IN HOUSE REJECTION: KAIZEN

3a.4 Can not Assemble

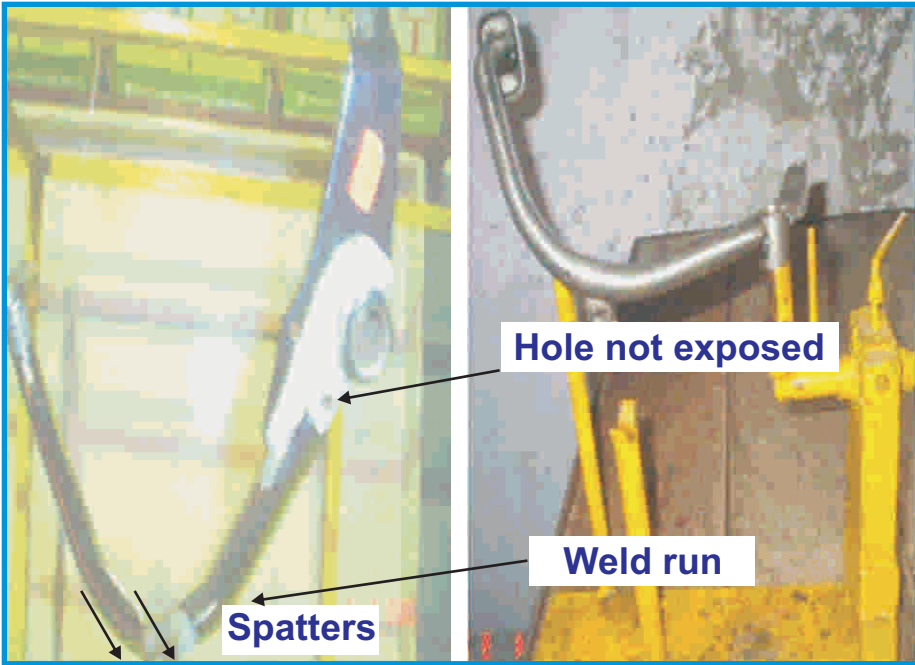
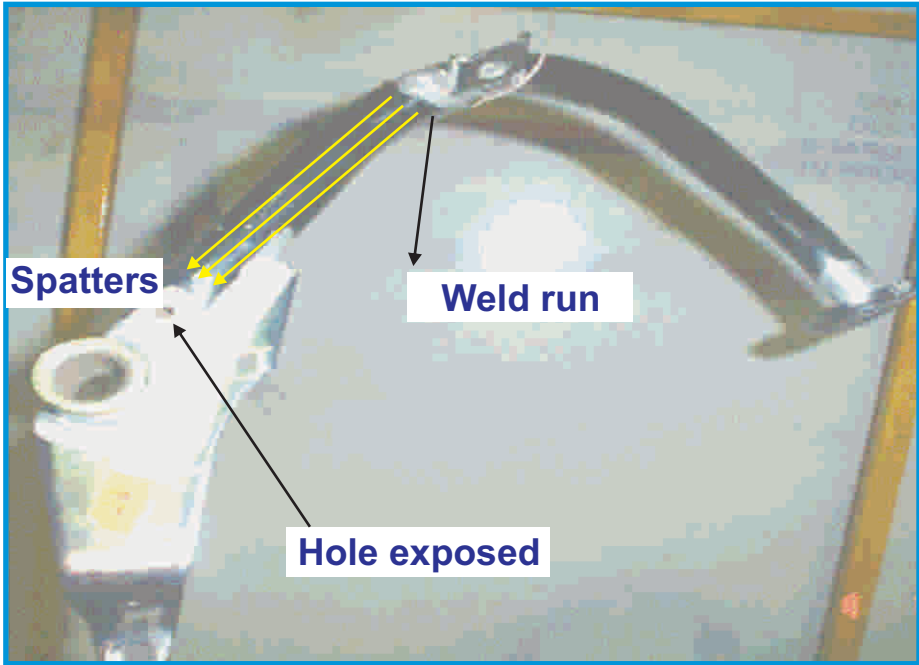
Physical Phenomenon : **Spatter in hole**
 Due to : Man / Machine / **Method** / Material

Spatter enters inside hole

Root Cause : Hole Exposed
(Hole position below weld run).

Kaizen Idea : Hole not exposed.

Kaizen : Part position changed for
hole position above weld run.
